VERMONT APARTMENTS BID SET ADDENDUM-1

4327 S VERMONT AVE, LOS ANGELES, CA 90037

COVERSHEET

CONSTRUCTION
LAYOUT PLAN

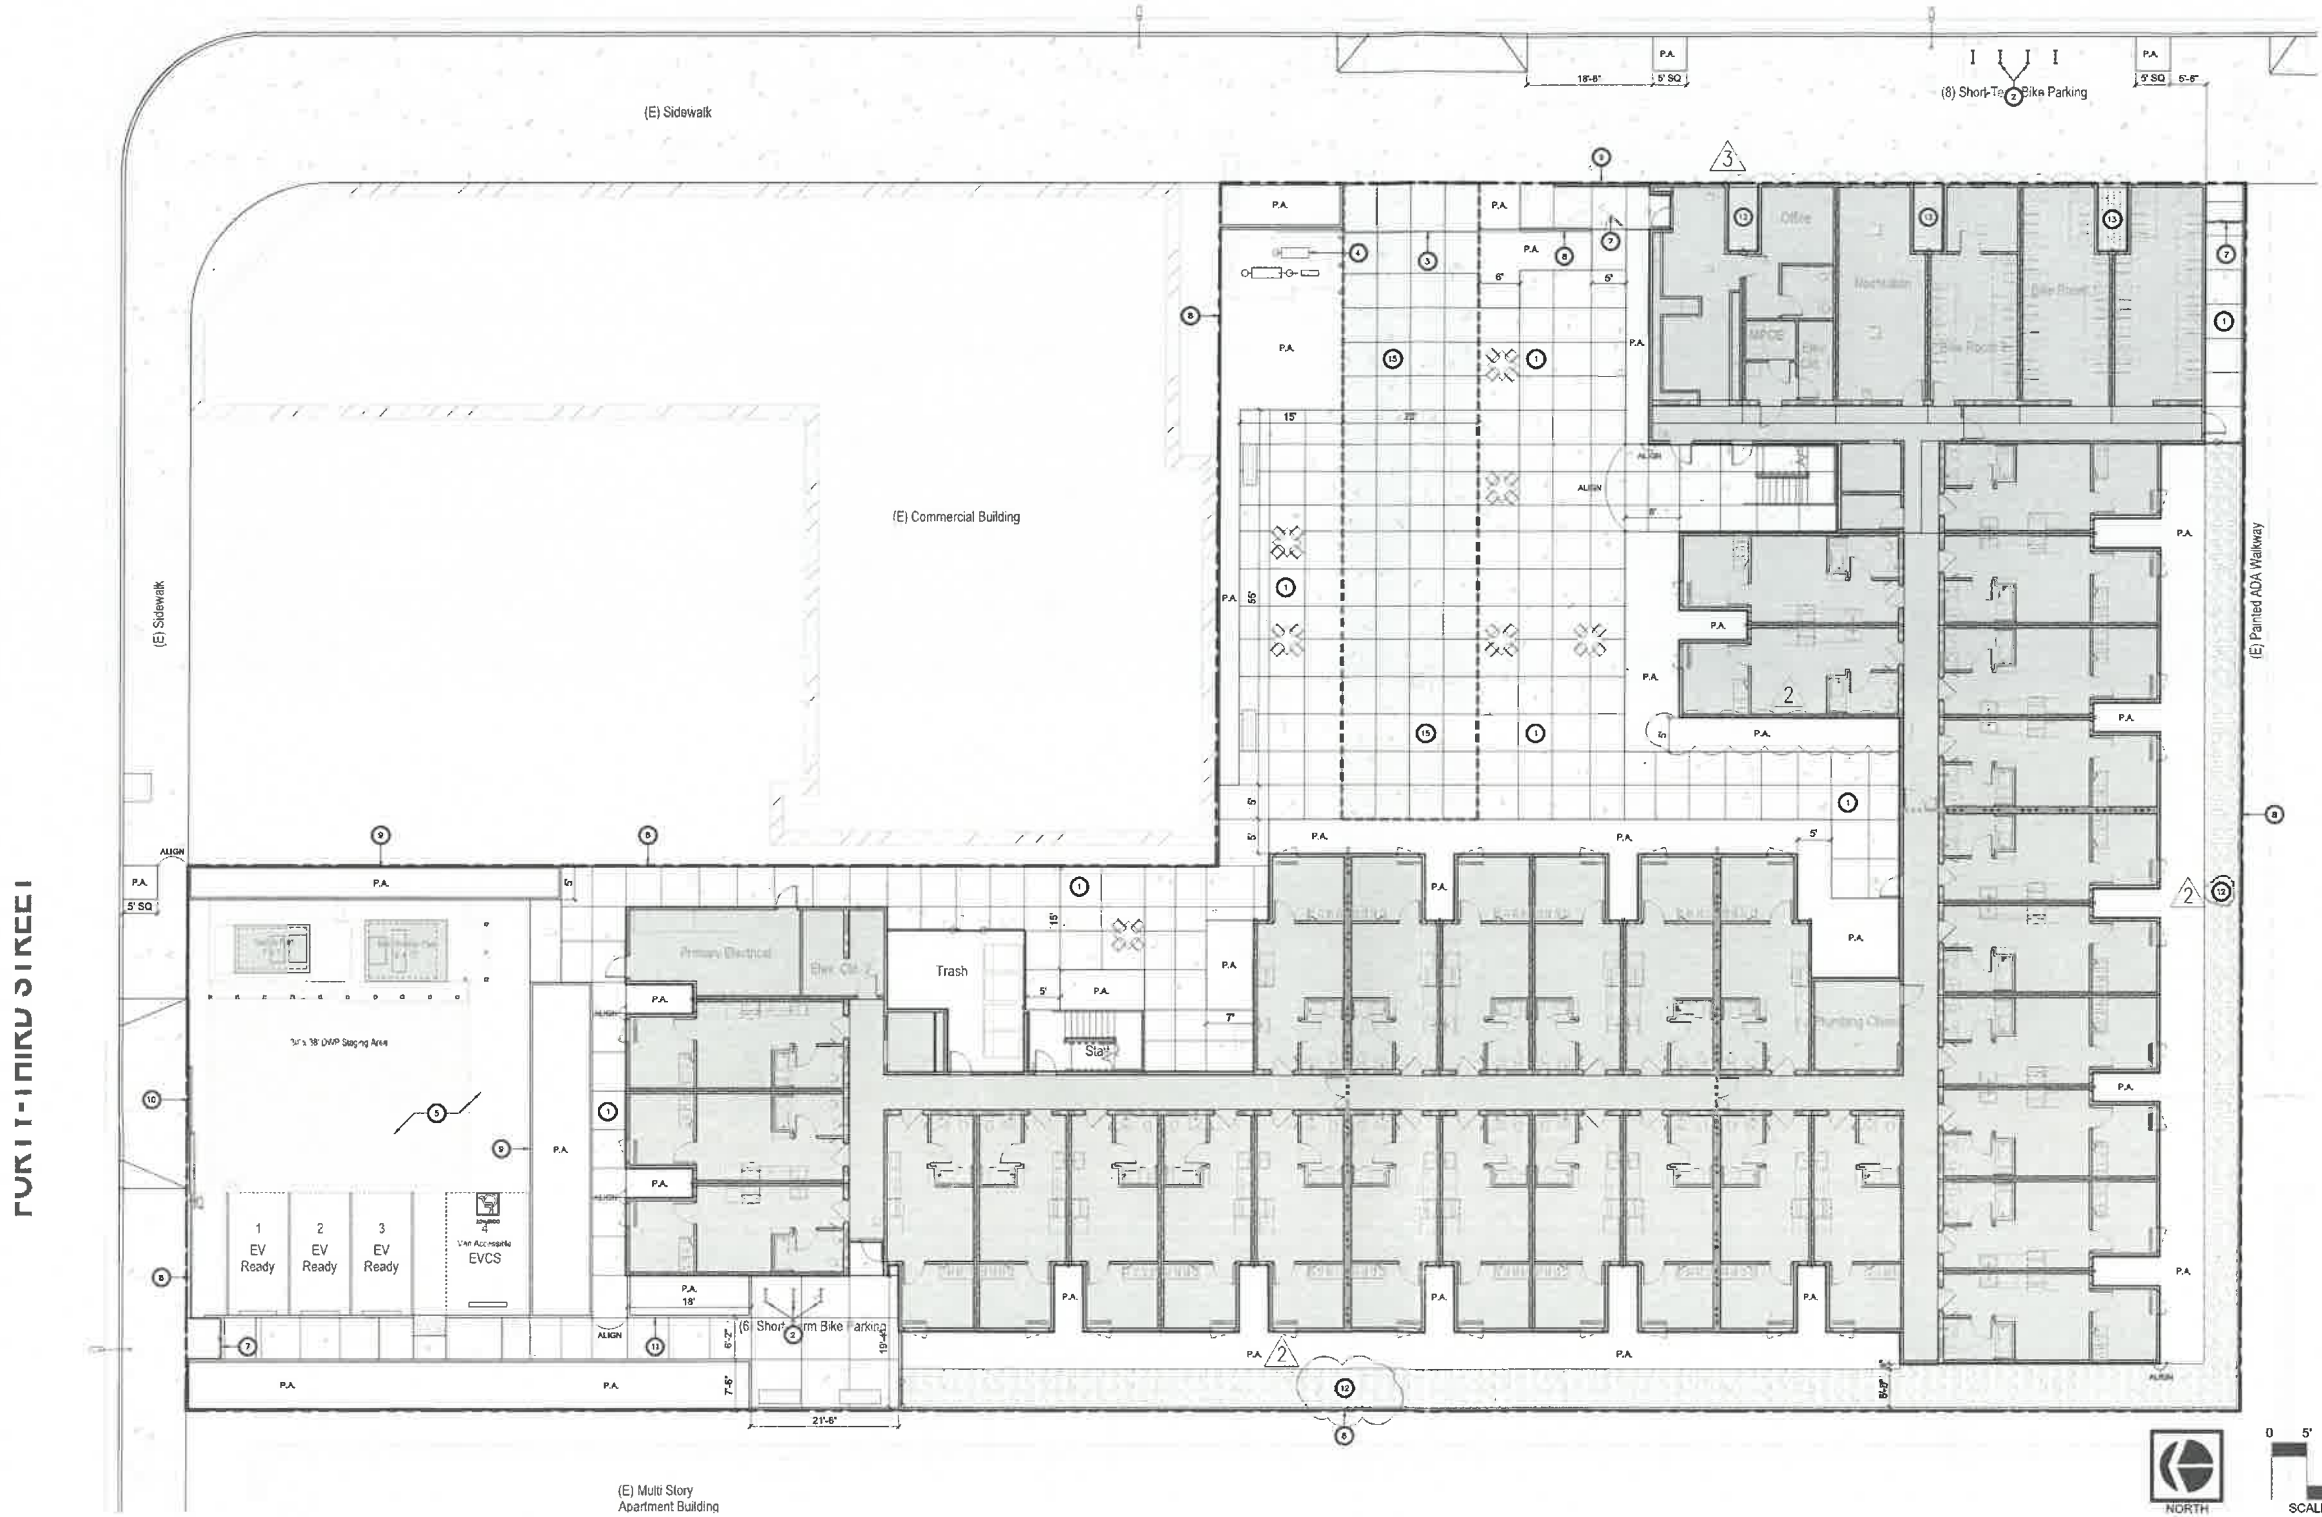
1	Removal of Cistern and Eq	5/19/25
2	3rd Plan Check Submittal	10/03/24
3	2nd Plan Check Submittal	09/05/24
4	1st Plan Check Submittal	07/05/23
No.	Revision / Issue	Date
